PAVING PLAN
1942
N.Y. COURT
N.E. 3rd St
LOT 5-BLK B

1942
NEW YORK COURT - N.E. THIRD TO LOT 5-BLOCK-B

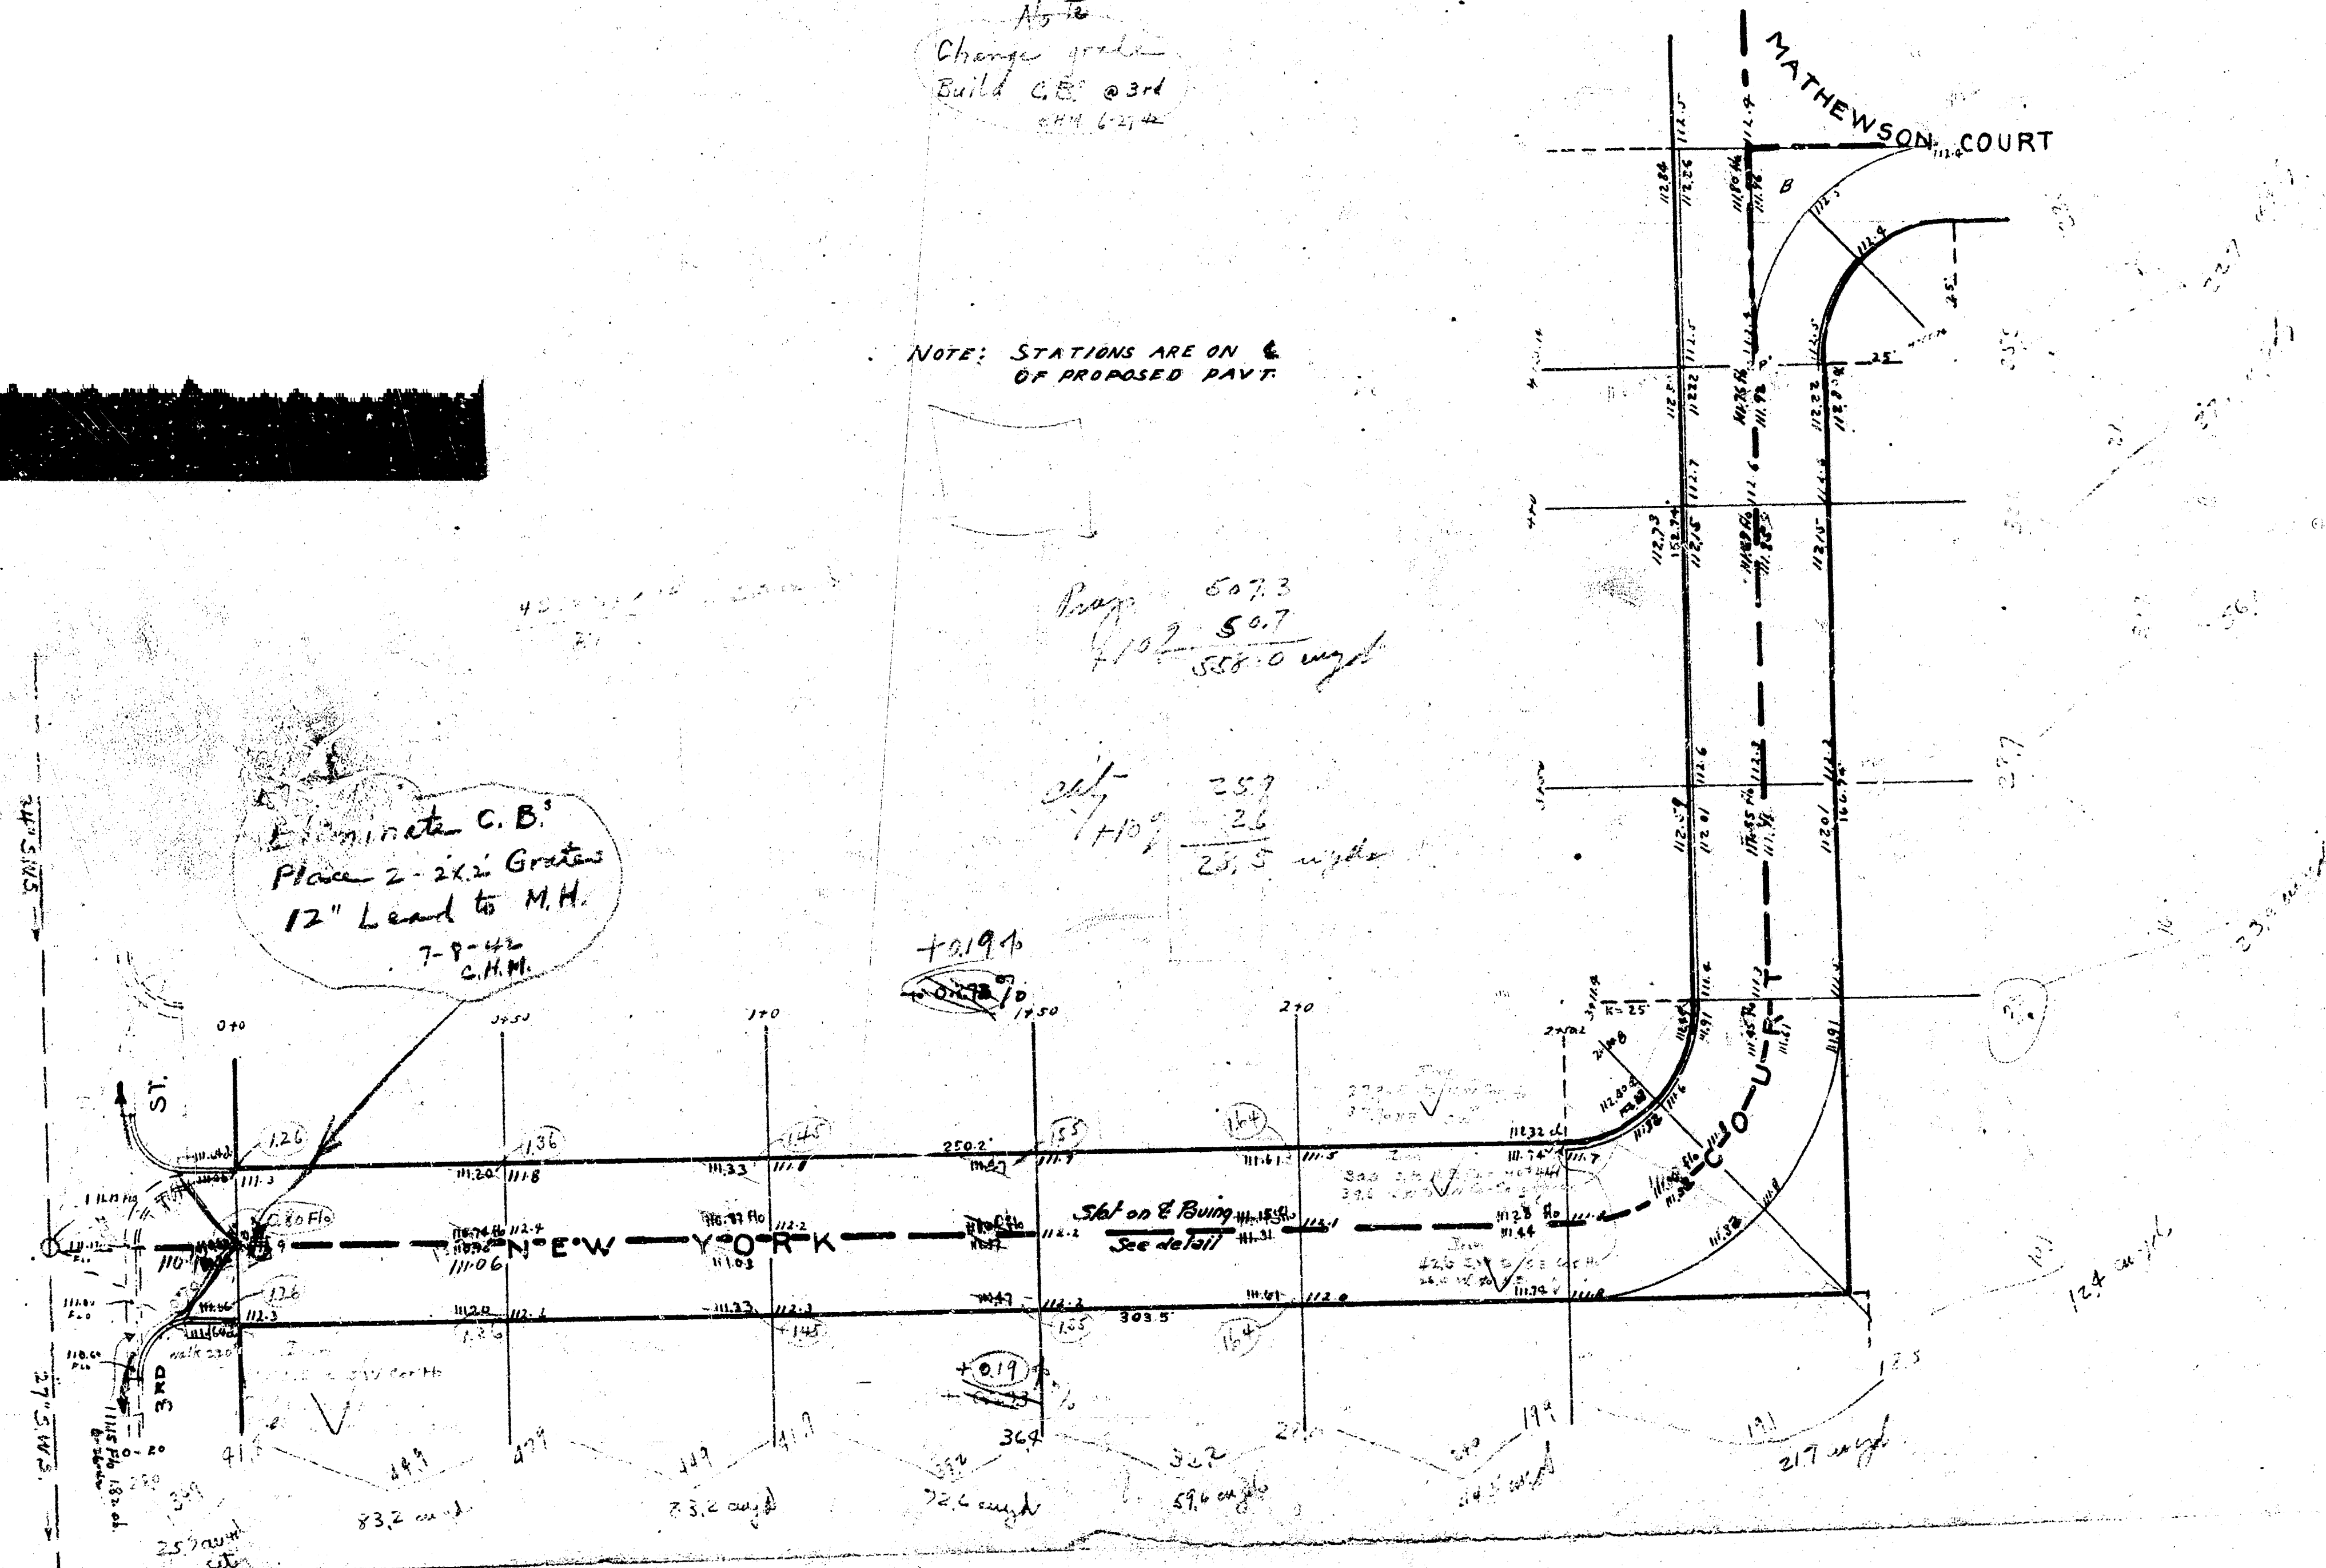
Also to
Change grade
Build C.B. @ 3rd
C.H.M. 6-27-42

Eliminate C.B.
Place 2-2x2 Grates
12" Lead to M.H.
7-9-42
C.H.M.
